Addendum No. 2

City of Coquitlam

RFP No. 25-002

Burke Mountain Athletic Park Construction Services

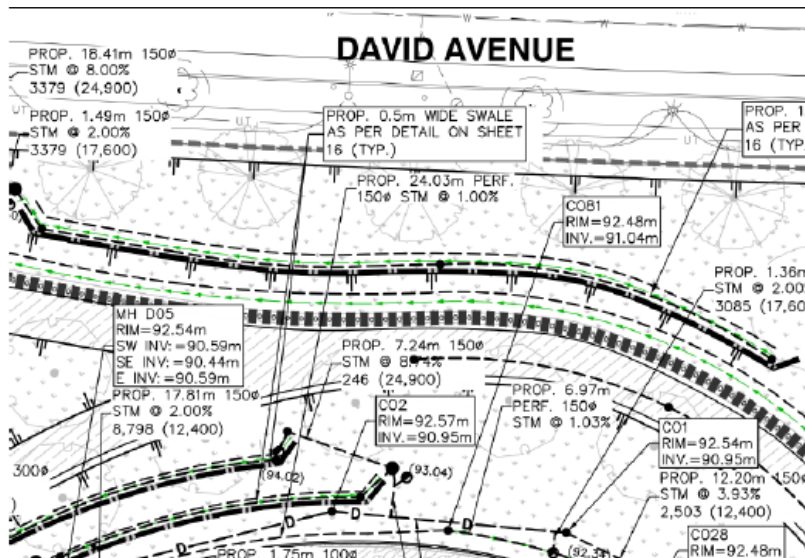
Q8. In Proposal Submission Form Unit price item #17 HDPE Perforated Pipe, this is very difficult to price, we need size for this pipe and where it supposes to be installed, cost can vary.

A8. See R1 above, this has been removed from REVISED Proposal Submission Form REVISION No 2.

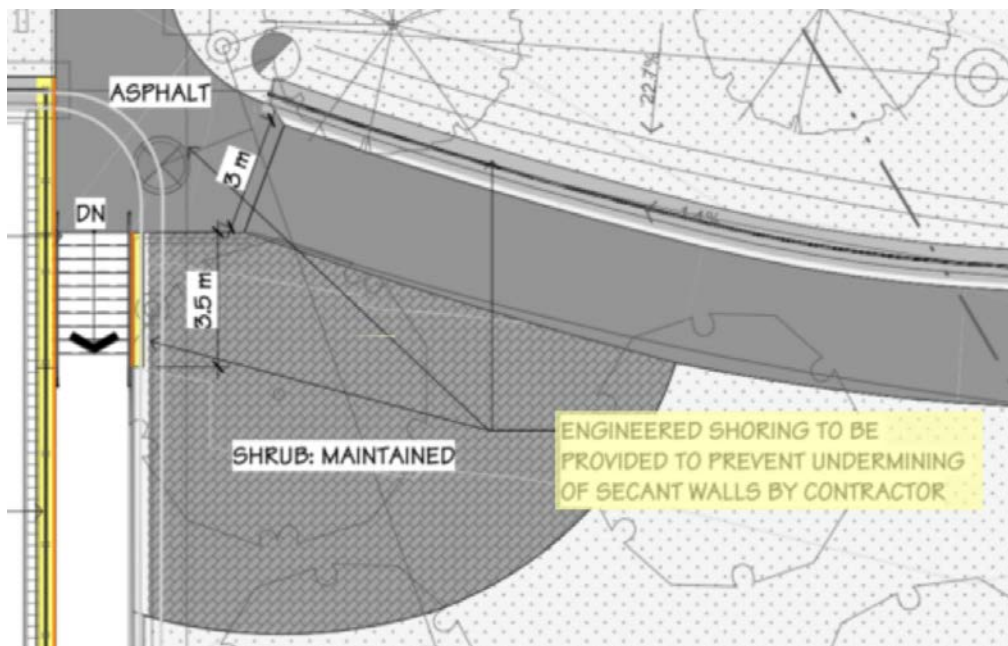
Q10. Could you please confirm what these circular symbols represent, and whether an updated legend or key is available?

A10. The solid circle in the snippet is a manhole, as identified on the legend on same sheet. The other block with half solid hatch is a lawn basin as identified on the legend on standard notes sheet and grading plans c/w reference to the applicable standard drawing.

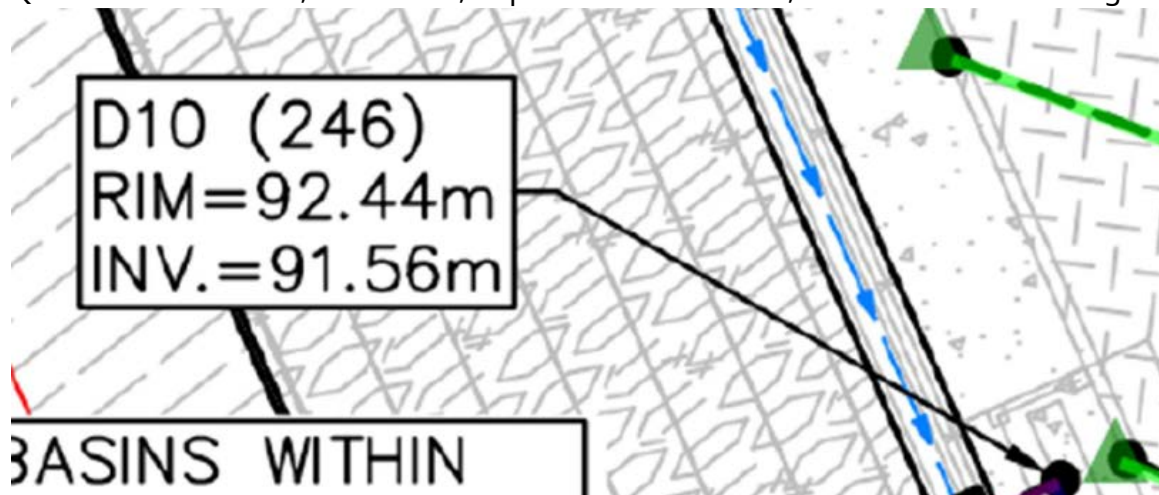
Q13. There is a note on drawing 14 of 26 indicates all Catch basin must have this type of grate and covers, these are from US and will be expensive beside tariff may apply. These cast products are only for New Catch Basins (Not for manholes)

A13. An equivalent product that can be locally sourced is acceptable, as long as it meets the BCBC requirement for accessible paths i.e. it should have no opening that will permit the passage of a sphere more than 13mm in diameter (3.8.3.2.3a). Additionally, it should be rated to withstand H-20 loading.

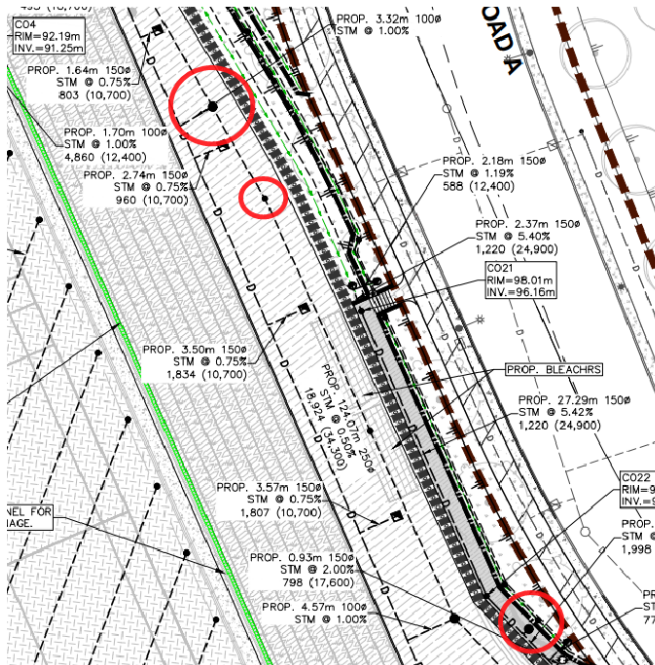
Q15. What is the D10, a cleanout, Cap end or Lawn basin, I didn't find it in the legend.

A15. The subject structure as identified on the legend on same sheet is a storm cleanout.

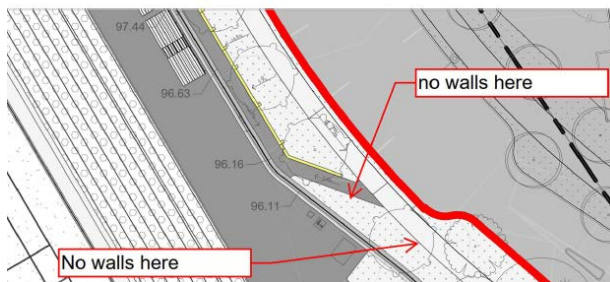
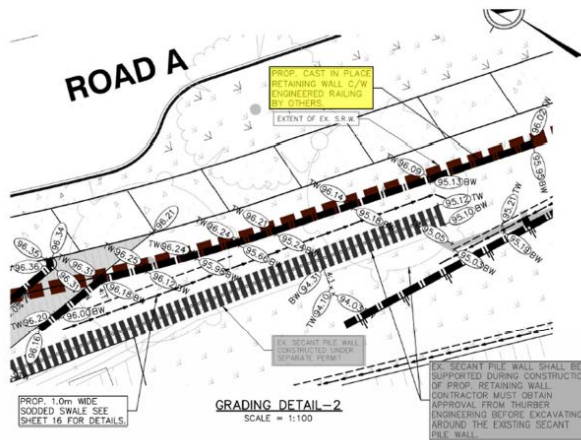
Q16. Can you clarify what the below civil markers are? If they are MH's, please provide rim and invert elevations.

A16. These are manhole and cleanouts. The rim and invert elevations are included in Architectural Addendum #01 – sheet 20 of 26 of civil drawings.
